Staff Report

Cloverleaf Truro Rental Housing Comprehensive Permit

SITE PLAN
CLOVER LEAF DRIVE, OFF HIGHLAND ROAD, TRURO, MA

Re: Peer Review
Cloverleaf Parcel
Highland Road
Truro, Massachusetts

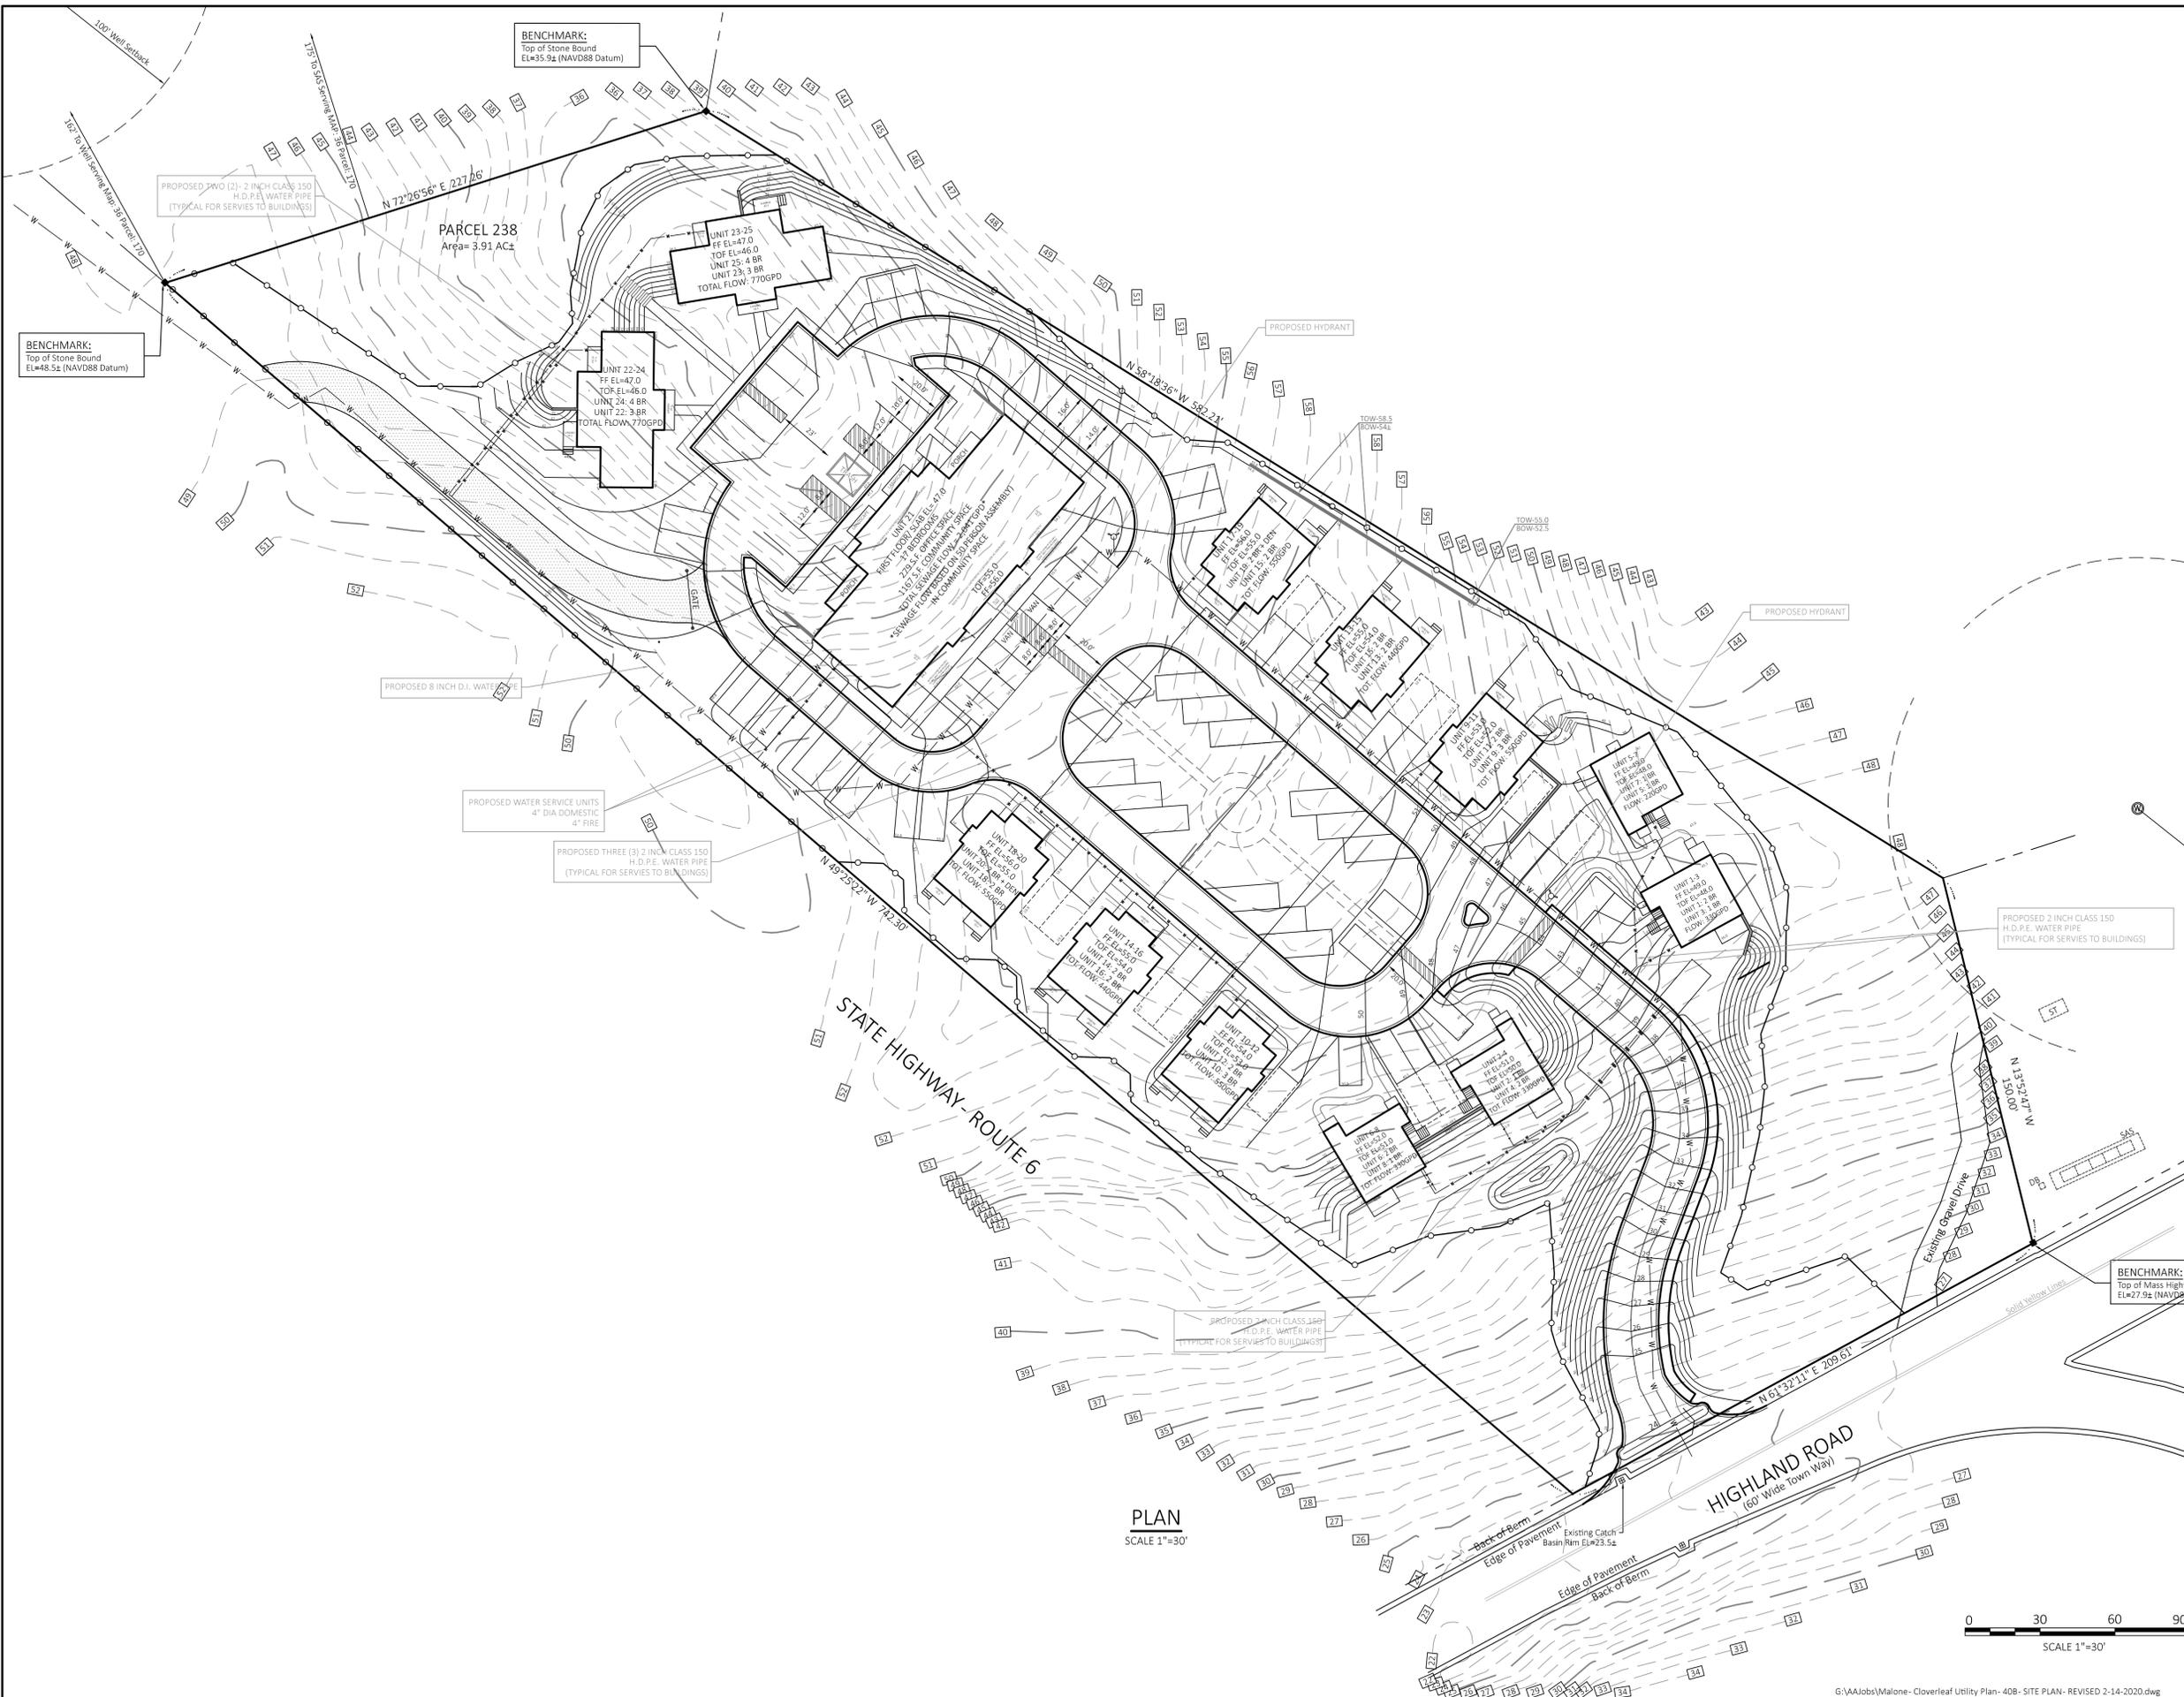
1. The applicant should provide data on hydrant flow tests to confirm the water supplied to the property will meet design requirements for fire protection.
2. Information on transformers and site lighting are not shown. HW recommends locating these on the plan to avoid conflicts with parking, landscape and other utilities (water, sewer, gas, septic) conflicts.
3. Other utilities (gas, electric, CATV, telephone) that will be located within driveway layout should be shown on the cross section.

1. HW recommends a phasing plan be provided for construction.
2. No erosion and sedimentation control (ESC) measures are currently shown. These are particularly important during construction, on steep slopes (2:1 in many areas), and for the protection of leaching areas (septic and stormwater) from compaction during construction. HW recommends that the Applicant provide ESC for both during construction as well as post-construction site stabilization.

3. Cut and fill calculations were provided. These are difficult to follow as the grading plan does not show adequate detail. HW recommends that this calculation be revised once the plans are further developed.

4. The Applicant states that salvaged ground cover will be reused onsite. HW recommends a stockpile location be indicated on the plans with information on how the area will be protected from erosion during construction. Additional areas for topsoil and other materials to be stockpiled should be indicated.

5. The buffer to the Route 6 property appears to only be 10-feet in certain areas. HW recommends a larger buffer be provided.
6. It appears that trees/shrubs are proposed over septic leach field, and possibly over the stormwater infiltration systems. HW recommends a landscape plan that overlays utilities so that there are no conflicts.

7. The detail for the driveway pavement cross section shows a crown but some areas of the driveway seem to be not crowned.
8. The driveway has a fairly steep slope and narrow width, HW recommends that the Applicant confirm that they have received input/approval from the Fire Department about their revised site access road design.

9. It appears that not all parking spaces have been graded and there are dashed lines that indicate double-stacked spaces. HW recommends that the Applicant verify that all parking spaces are feasible and meet the minimum requirements (handicapped spaces as well).

10. One dumpster has been shown near the large building. HW requests that the Applicant confirm this is adequate (in size, distance from all units, and location for pickup by trucks) and that additional locations are not required.

11. HW recommends that areas for snow removal be shown on the plan. The driveway is fairly narrow and there is not a lot of area outside of the driveway and parking spaces that is not occupied by stormwater or wastewater systems.

SEWAGE-DRAINAGE SITE PLAN- 40B PERMIT SET
 CLOVER LEAF DRIVE, OFF HIGHLAND ROAD, TRURO, MA

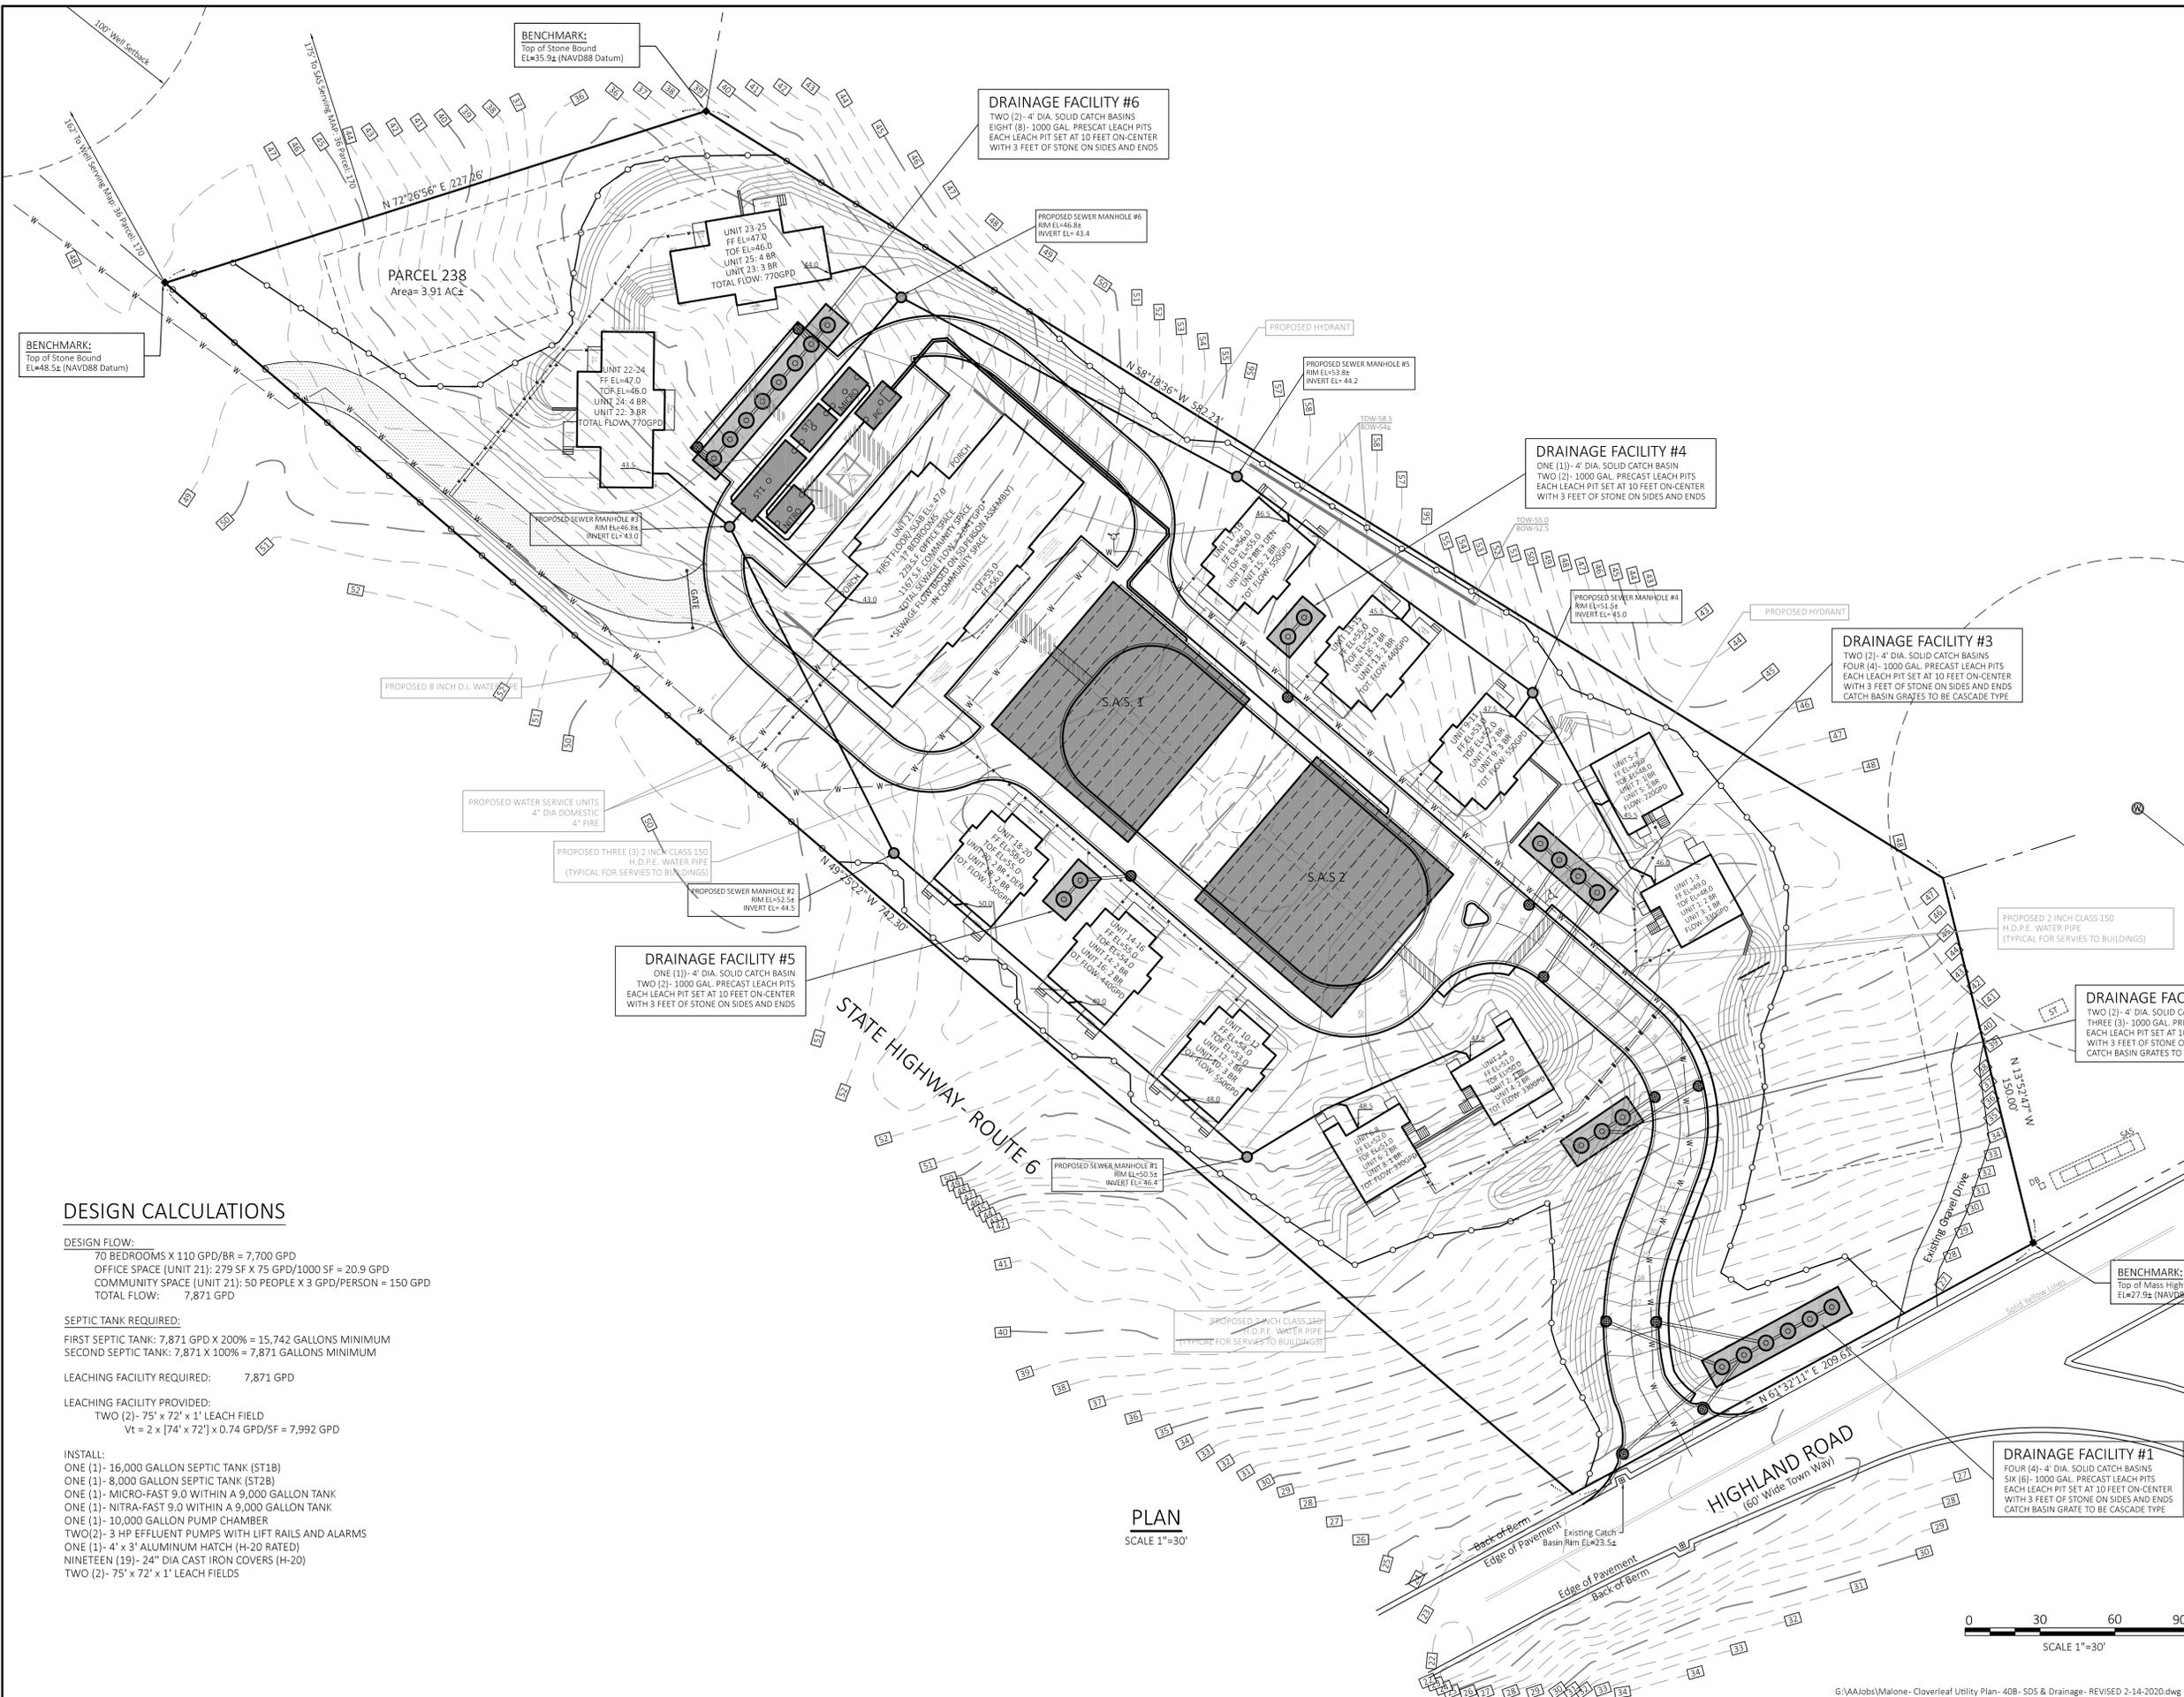
1. The applicant appears to have included reserve areas for the septic leaching facilities on the north and south ends of the property, but these are not labeled on the plans. The existing and proposed topography on the site would likely require any reserve area to be constructed in fill and/or have a significant amount of grading. The applicant should provide additional design information to confirm that these locations can function as reserve areas and meet all the Title 5 requirements for construction of a leaching facility in an area that has a significant change in topography. The applicant should also document that the proposed effluent pumps will function properly in the event the reserve areas must be utilized.

2. Test pits do not appear to have been performed in the areas of the proposed leaching facilities. The plans note that one boring was dug using a hand auger, but the location is not indicated on the plans. Title 5 requires a minimum of two deep hole test pits in the primary leaching areas and two in the reserve areas along with percolation tests.

3. Elevations should be provided on the top of tanks and leach field to ensure the minimum/maximum cover over the entire system meets Title 5 and/or H-20 loading as required.

4. Pipe sizes/slopes are not labeled. HW recommend 6" minimum and cleanouts at bends where no manholes are proposed. Additionally, it appears that portions of the septic system piping will be located underneath "landings" with steps on some of the buildings including units 17-18, 13-15, 10-12, 14-16, and 18-20. HW recommends locating sewer lines away structures or footings.

5. Final plans should demonstrate that setbacks are being met (leach field to drainage system), particularly in the areas of Drainage Facilities #4 and #5. This also applies to any roof drainage facilities that are currently not shown.

SOIL ABSORPTION SYSTEM DETAIL:

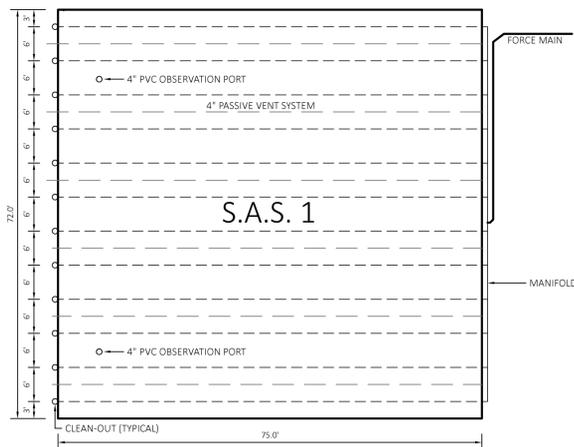
6. The leach field detail should clearly label the 5-foot minimum estimated seasonal high groundwater (ESHGW) separation, along with an explanation of how the ESHGW was determined. The applicant will also need to document that groundwater mounding will not impact the minimum separation between the bottom of the leaching field and groundwater. Given the dept to water, this should not be a problem in the primary leaching areas but might be an issue in the reserve areas.
7. HW recommends allowing for more than one day of storage in the pump chamber as a safety factor to account for potential power outages. Alternatively, backup power could be provided.
8. HW recommends that the Applicant provide information on the operation and maintenance (O&M) for the septic system components.
